Banks and Gesso, LLC

22 April 2003

RE: CEMEX, Inc Lyons Mine Permit No. M-1977-208 (SI-01)
Reclamation Cost for Demolition of the Cement Plant

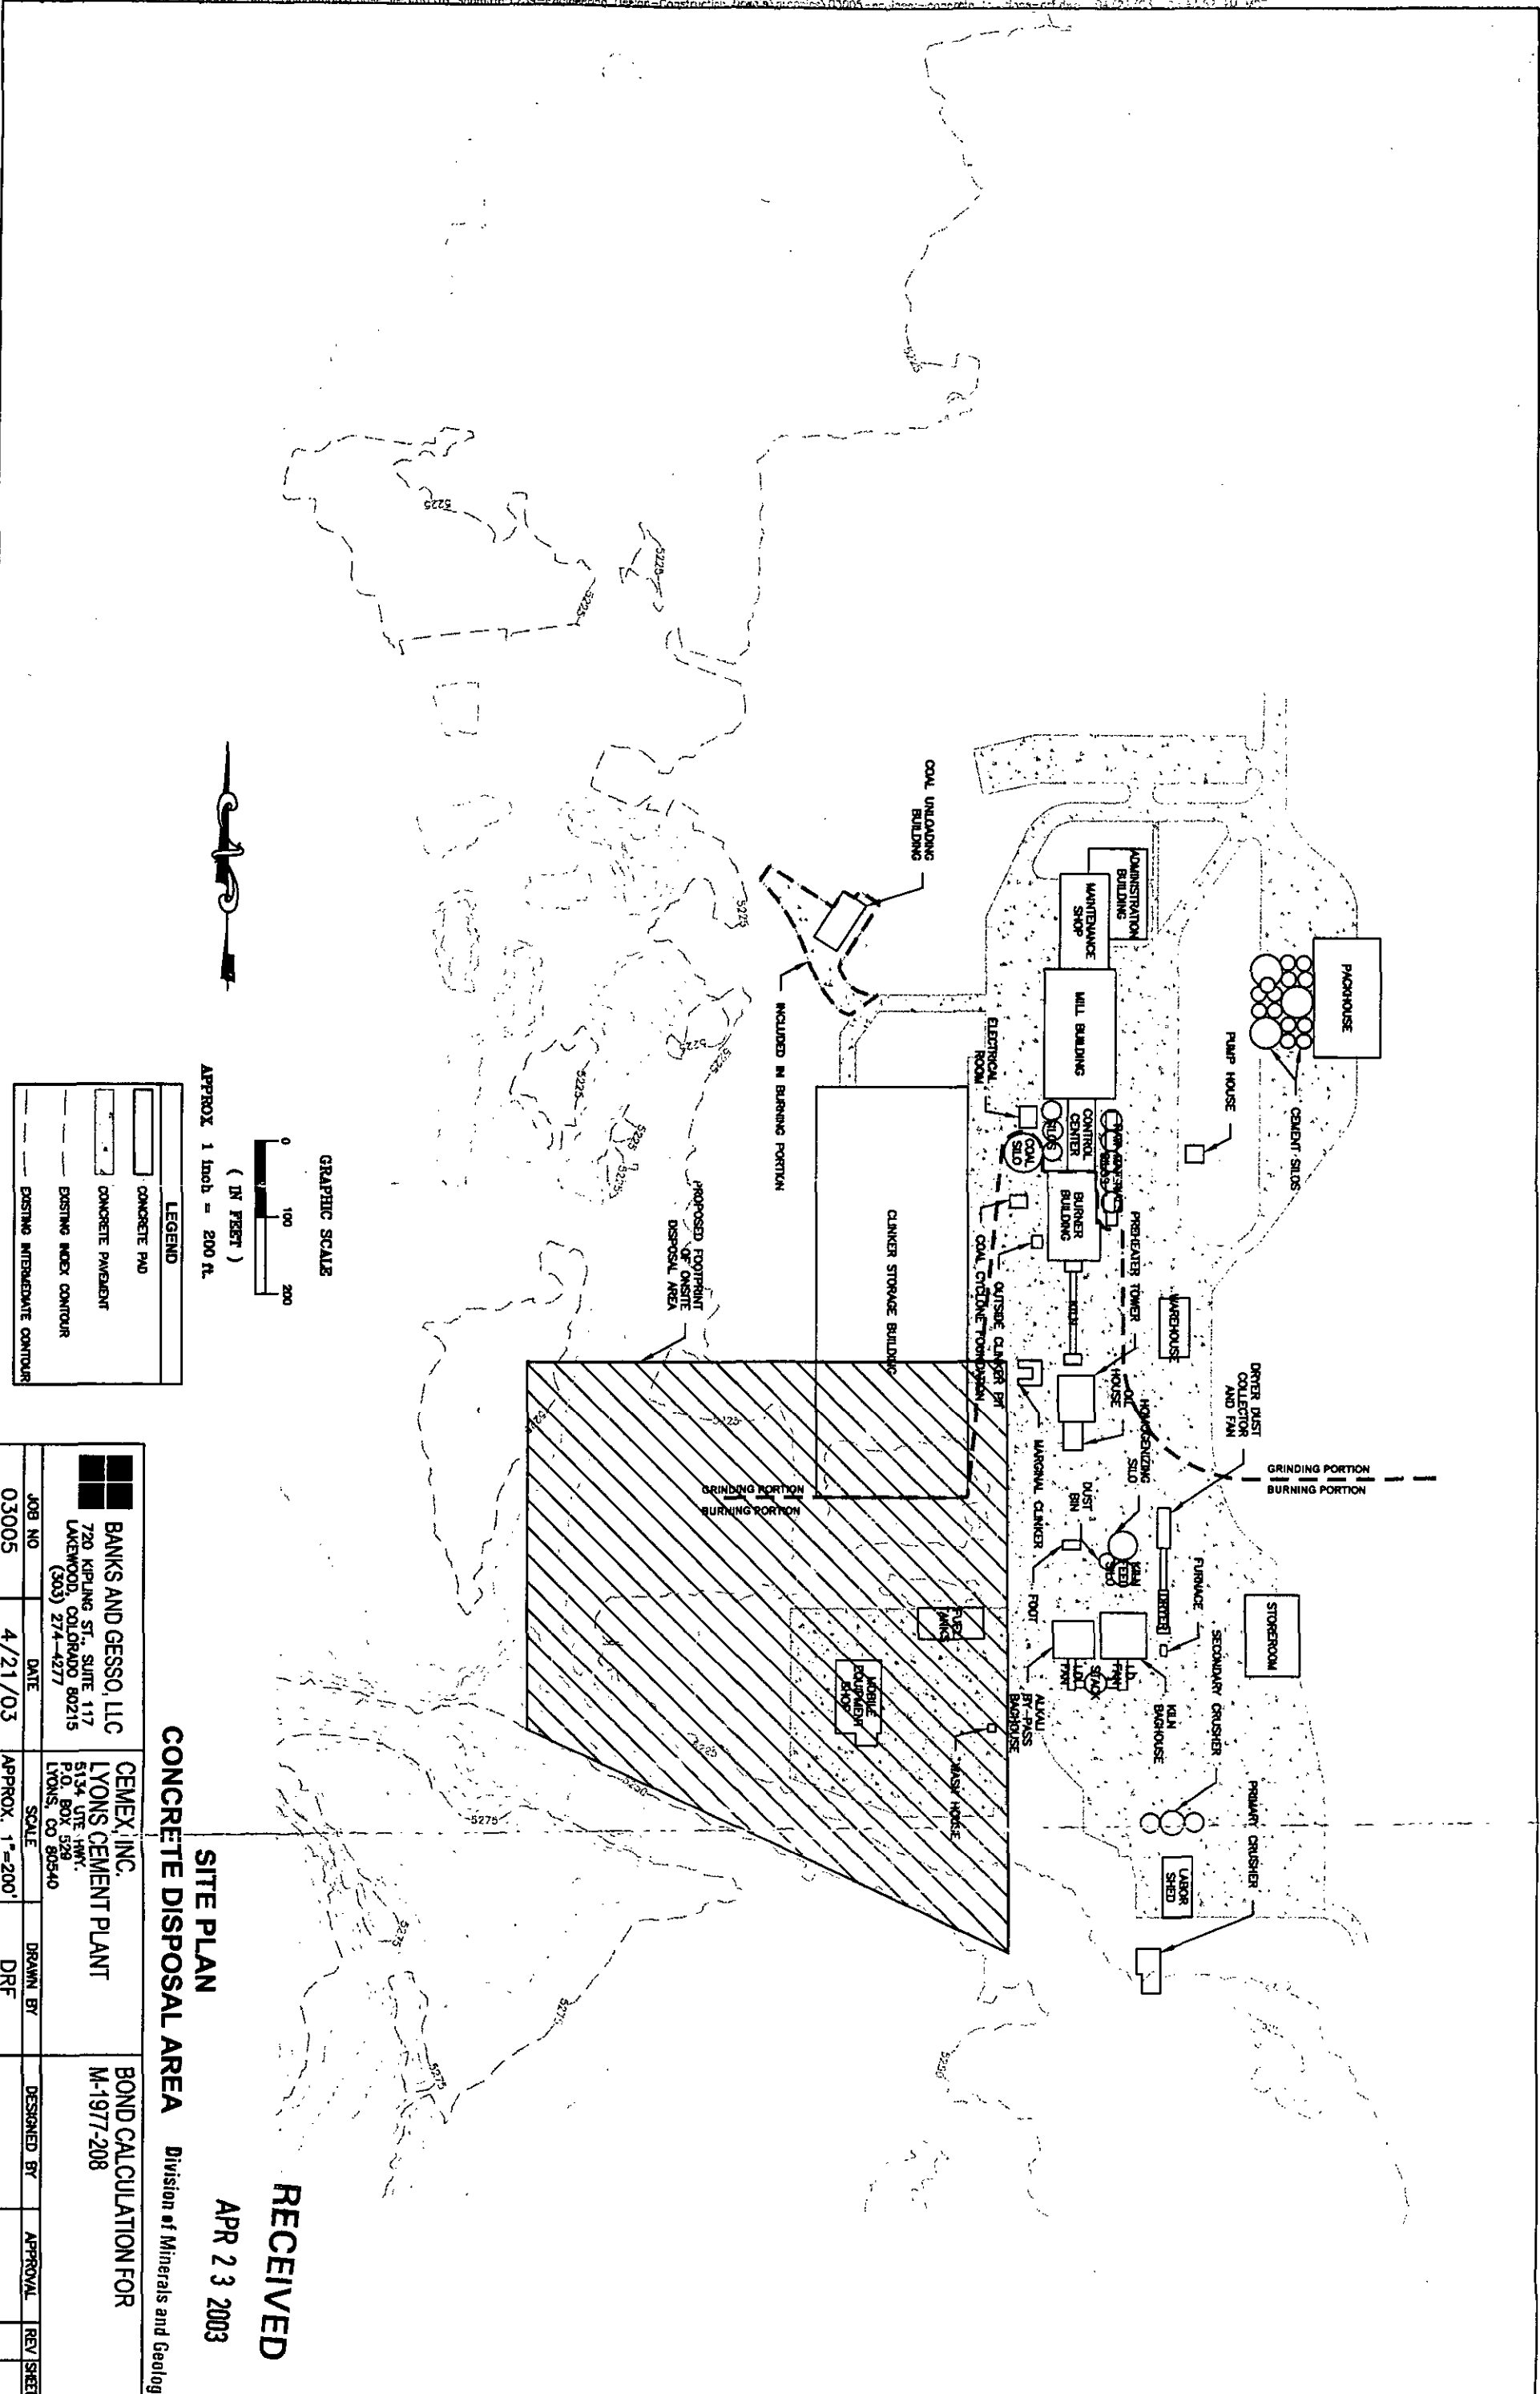
5. CEMEX provided a bond calculation map that is very helpful in determining the nature and location of structures at the cement plant. However, the map did not contain a scale necessary to determine the size of the structures. Please notify the Division as to the scale of the map, or provide a new map depicting a scale.

An approximate scale has been added to the schematic plan provided for this submittal. However, dimensions were taken from the engineering drawings, not scaled from a plan view map.

The site was divided into two areas for the estimate; the north part of the site is referred to as the Grinding portion, and the south part is referred to as the Burning portion. This division between the two processes allows a separate bond calculation in the event that the plant is modified so that only the Grinding process occurs in the future. The drawing included with this report depicts the division.

The selected disposal site is along a hogback ridge at the south end of the plant site (see site plan map). The disposal site will accommodate approximately 175,000 cubic yards of concrete. The disposal area will require only minor regrading to receive a geosynthetic liner with the appropriate permeability requirements. The disposal site will be capped with three feet of engineered fill, compacted per specifications and revegetated. The borrow source for the fill is located on the Cemex, Inc. Lyons Mine site, two miles or less from the location of the selected disposal site. Additional information on the disposal site including dimensions, the relationship to groundwater and surface water, and material placement techniques will be addressed in the Technical Revision.
